SITE VISIT REPORT No. 1 | May 2, 2022

Ramova Theater

Facade Repairs

REPORT DATE	May 6, 2022	WJE PROJECT NO.	2020.1161.1
REPORTED BY	Amanda Marshall	WJE PROJECT MGR.	Rachel Will
OWNER/ CLIENT	Dan O'Riley O'Riley Office 1516 South Wabash Avenue, Unit 1002Chicago, Illinois 60605	CONTRACTOR/ PROJECT NO.	James McHugh Construction (McHugh)
PRESENT AT SITE	Amanda Marshall (WJE) Eamonn Connolly (McHugh) Dan O'Riley (O'Riley Office) Vatsal Desai (Baum Revision)	DISTRIBUTION	Rachel Will (WJE) Nicole Declat (WJE) Amanda Marshall (WJE) Jennifer Gee (McHugh) Eamonn Connolly (McHugh) Dan O'Riley (O'Riley Office) Vatsal Desai (Baum Revision)

Figure 9. View of opening for new limestone knee wall

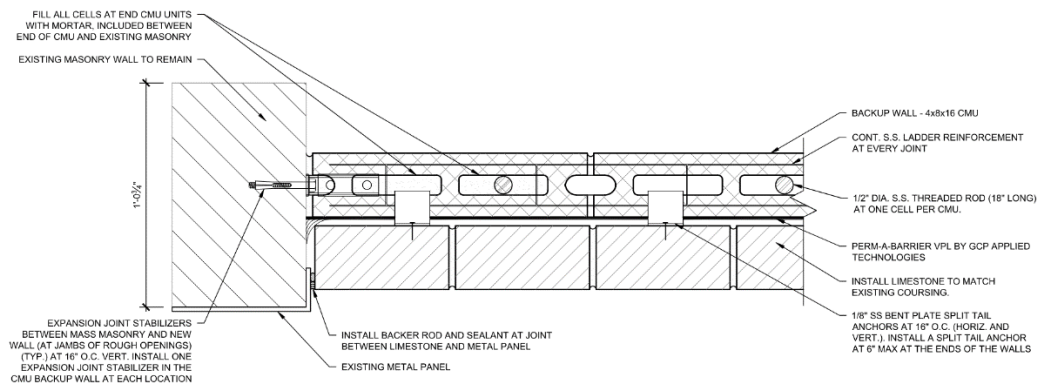
9	<p>New Limestone Knee Wall at Bridgeport News Building: WJE reviewed the area at the east facade of the Bridgeport News Building where an existing storefront door system had been removed to accommodate a new limestone knee wall with a concrete block backup and a new storefront window system (Figure 9). McHugh noted that the existing tile floor will be removed prior to installation of the new limestone wall system. McHugh reported that the new wall would not be flashed or waterproofed. WJE has prepared the proposed detail for the construction of the limestone clad knee wall including the installation of flashing and waterproofing membrane, as well as anchors and interface detailing for the new wall with the existing wall (Figure 10).</p>	WJE
